SUBJECT: NEW VEHICLE DEMONSTRATION / DELIVERY HOLD

Safety Recall 25S82 -*Supplement #1*

Certain 2023-2025 Model Year F-150 Vehicles Equipped with 9.75" HD Axle – ¾ Float Axle

New! REASON FOR THIS SUPPLEMENT

FIGURE 4

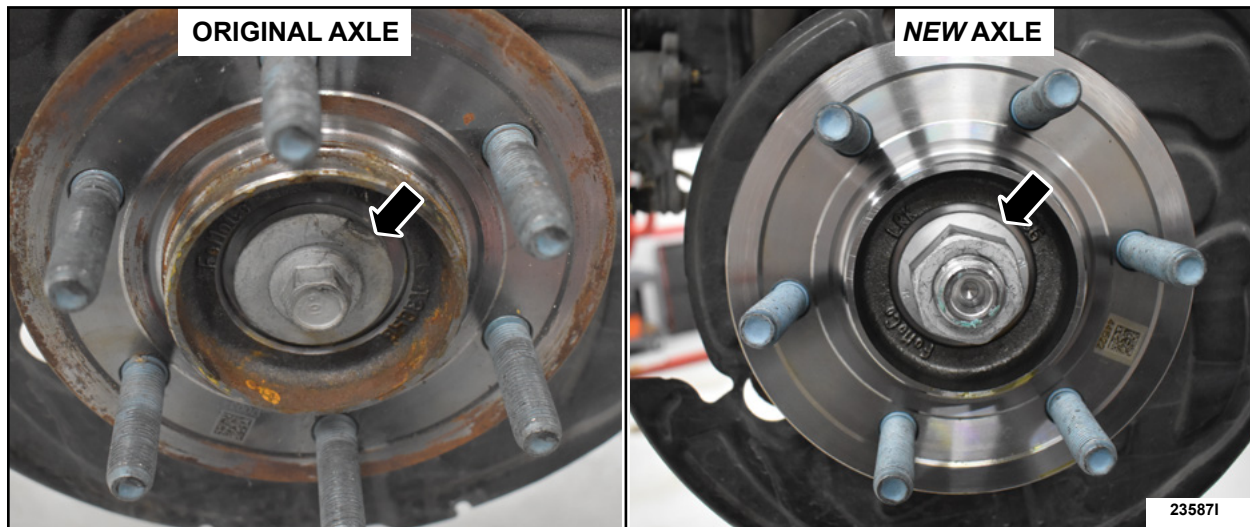
NOTE: The original axle has a bolt in the center to secure the hub to the axle shaft, the new axle is threaded and secured with a nut. See Figure 4.

FIGURE 5

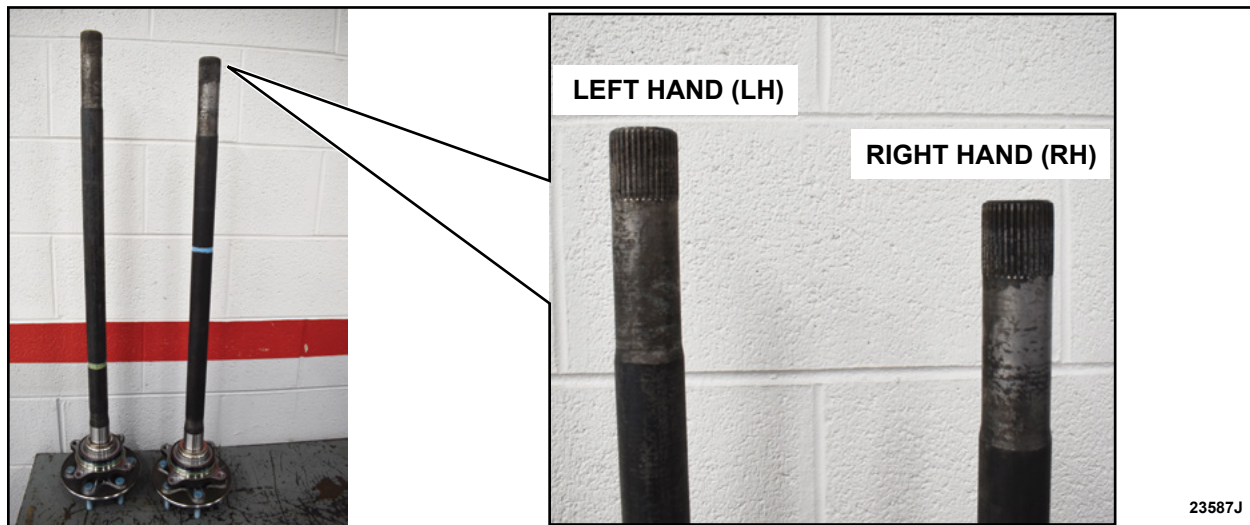
NOTE: The Right Hand (RH) side axle is shorter than the Left Hand (LH) side axle. See Figure 5.
